Product Change Notice (PCN)

PCN Number: PCN-0451186R-01

Product(s) Affected: *PJ-050AH*

PREVIOUS CUI DEVICES DETAIL / IMAGE	NEW CUI DEVICES DETAIL / IMAGE

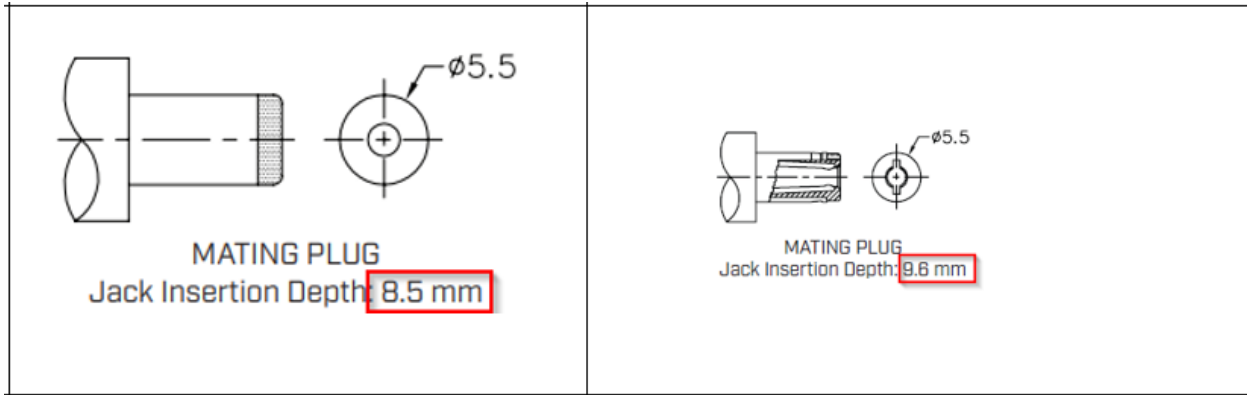
Description of Change: *Mechanical, electrical, and material changes as shown below:*

<p style="text-align: center;">PCB LAYOUT TOP VIEW</p>	 <p style="text-align: center;">Recommended PCB Layout Top View</p>																																							
<table border="1"> <thead> <tr> <th></th> <th>MATERIAL</th> <th>PLATING</th> </tr> </thead> <tbody> <tr> <td>center pin</td> <td>copper</td> <td>nickel</td> </tr> <tr> <td>terminal 1</td> <td>brass</td> <td>silver</td> </tr> <tr> <td>terminal 2</td> <td>copper alloy</td> <td>silver</td> </tr> <tr> <td>terminal 3</td> <td>brass</td> <td>silver</td> </tr> <tr> <td>plastic</td> <td>PBT</td> <td></td> </tr> </tbody> </table>		MATERIAL	PLATING	center pin	copper	nickel	terminal 1	brass	silver	terminal 2	copper alloy	silver	terminal 3	brass	silver	plastic	PBT		<table border="1"> <thead> <tr> <th>DESCRIPTION</th> <th>MATERIAL</th> <th>PLATING/COLOR</th> </tr> </thead> <tbody> <tr> <td>center pin</td> <td>copper alloy(H65)</td> <td>nickel</td> </tr> <tr> <td>terminal 1</td> <td>C2680 t-0.35 mm</td> <td>nickel-tin</td> </tr> <tr> <td>terminal 2</td> <td>C5210 t-0.25 mm</td> <td>nickel-tin</td> </tr> <tr> <td>terminal 3</td> <td>C2680 t-0.30 mm</td> <td>nickel-tin</td> </tr> <tr> <td>housing</td> <td>PABT (UL94V-0)</td> <td>black</td> </tr> <tr> <td>cover</td> <td>PABT (UL94V-0)</td> <td>black</td> </tr> </tbody> </table>	DESCRIPTION	MATERIAL	PLATING/COLOR	center pin	copper alloy(H65)	nickel	terminal 1	C2680 t-0.35 mm	nickel-tin	terminal 2	C5210 t-0.25 mm	nickel-tin	terminal 3	C2680 t-0.30 mm	nickel-tin	housing	PABT (UL94V-0)	black	cover	PABT (UL94V-0)	black

MATERIAL	PLATING																																						
center pin	copper	nickel																																						
terminal 1	brass	silver																																						
terminal 2	copper alloy	silver																																						
terminal 3	brass	silver																																						
plastic	PBT																																							
DESCRIPTION	MATERIAL	PLATING/COLOR																																						
center pin	copper alloy(H65)	nickel																																						
terminal 1	C2680 t-0.35 mm	nickel-tin																																						
terminal 2	C5210 t-0.25 mm	nickel-tin																																						
terminal 3	C2680 t-0.30 mm	nickel-tin																																						
housing	PABT (UL94V-0)	black																																						
cover	PABT (UL94V-0)	black
